DESIGN <i>gp</i>	DRAWN BY <i>gp</i>	DART AEROSPACE LTD HAWKESBURY, ONTARIO, CANADA	
CHECKED <i>#</i>	APPROVED <i>#</i>	DRAWING NO. DSI 9329	REV. A SHEET 1 OF 1
DATE 06.04.25		TITLE BUBBLE WINDOW INSTALL MOD.	SCALE NTS
A	06.04.25	NEW ISSUE

DART SERVICE INSTRUCTION
TO AMEND INSTALLATION INSTRUCTIONS IIN-D044-713 REV. A
REF. CANADIAN STC: SH05-13 ISSUE 1
REF. FAA STC: SR02088NY

FIGURE 1

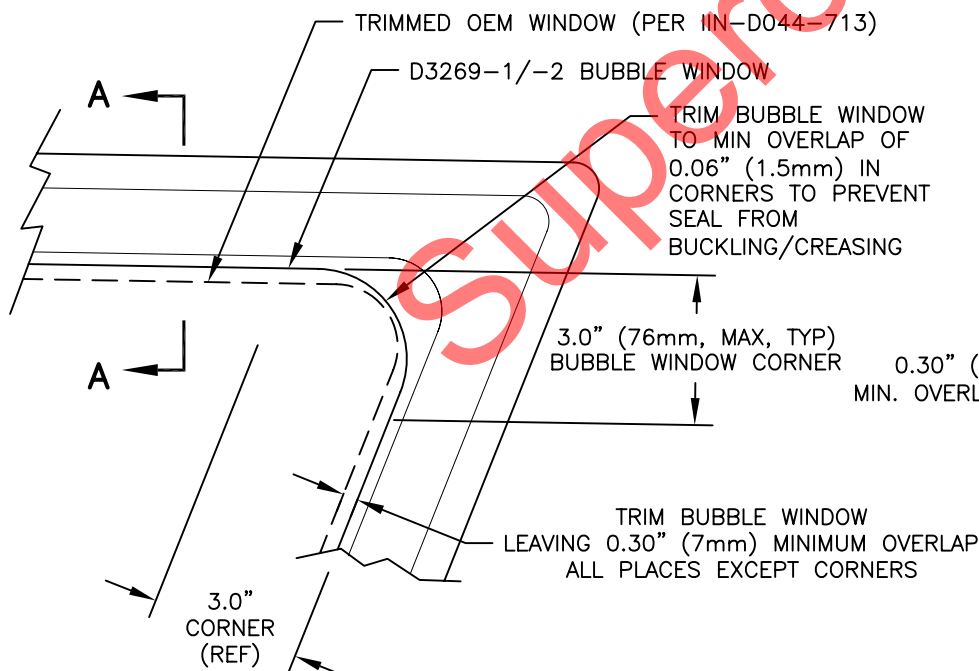
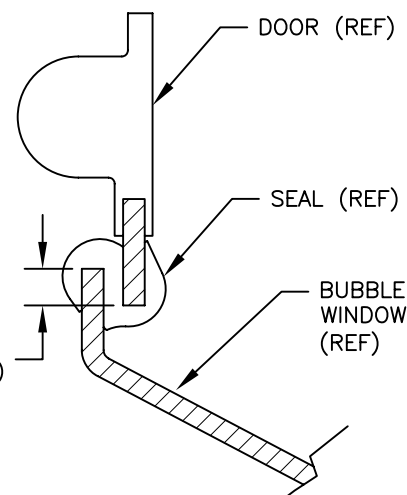
PURPOSE: For the D044-713-013/-014 kits supplied after B26748, the D3269-1/-2 bubble windows have been supplied untrimmed to allow for easier installation in the field. The installer must trim the windows in accordance with these instructions prior to installation.

- 1) Modify the R44 crew door per items 3.2.1 and 3.2.2 of Installation Instructions IIN-D044-713 Rev.A.
- 2) Fit and trim the D3269-1/-2 Bubble Window to match the cutout in the door as follows: The bubble window must be a minimum of 0.30" (7mm) larger than the cutout in the OEM window as shown in the figure below. However, in the corners of the window, it is acceptable to trim a 0.06" minimum overlap (1.5mm) to help prevent the D2126-0903 Seal from buckling/creasing in the corners. The edge of the bubble window must be deburred to a smooth finish.
- 3) Continue installing the bubble window per items 3.2.3 through 3.2.5 of the installation instructions.
